Jasmin Mediterranean Kitchen
11613 124th AVE NE STE #F
KIRKLAND, WA 98034

SHEET NUMBER
M-1

CITY OF KIRKLAND BUILDING DEPARTMENT	
Permit #	MNR15-05704 PLAN CASE: MECPS-01853
Address	11613 124TH AVE NE
Work Class	ALTERATION TO STRUCTURE OR SYSTEM
Project	
Owner	SANG M & CHUN O. KIM
Date Submitted	09/11/2015
Date Approved	
Reviewed By	<i>[Signature]</i> 9/29/15

FRONT VIEW
SCALE: 1/2" = 1'

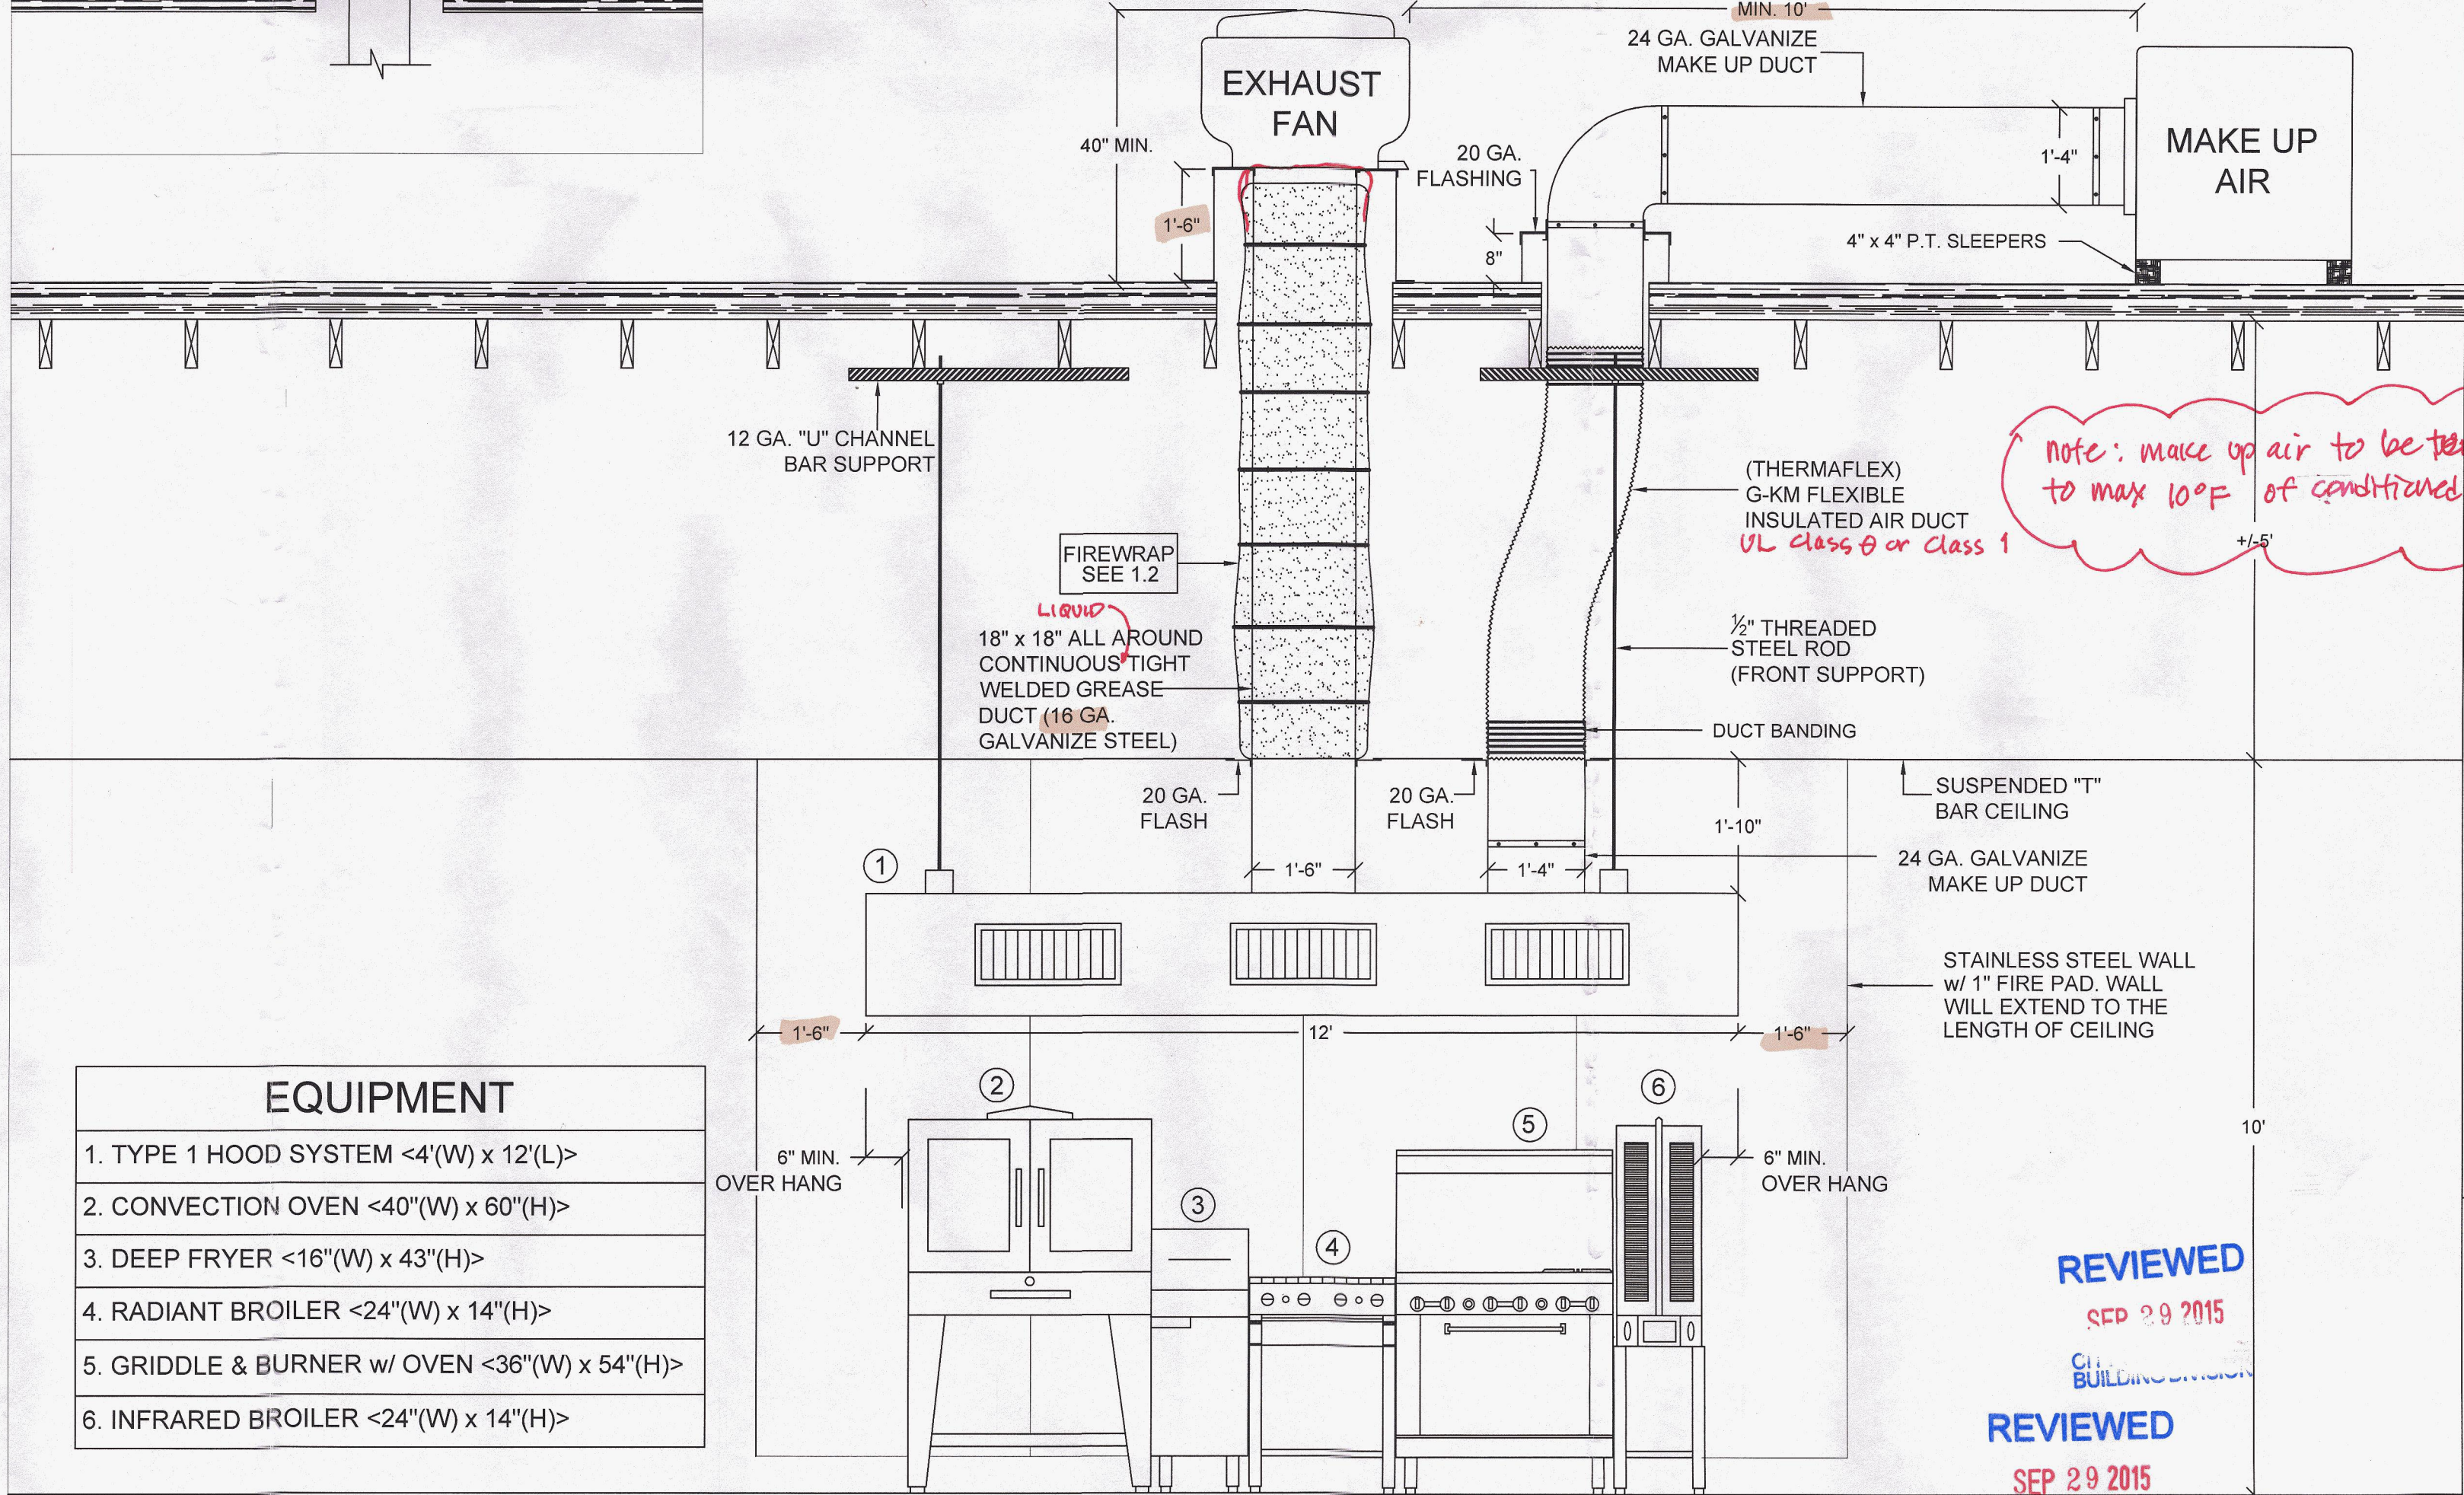
* Hood exhaust shall automatically operate when ever cooking operations occur. via heat sensors and interlock w/ cooking appliances
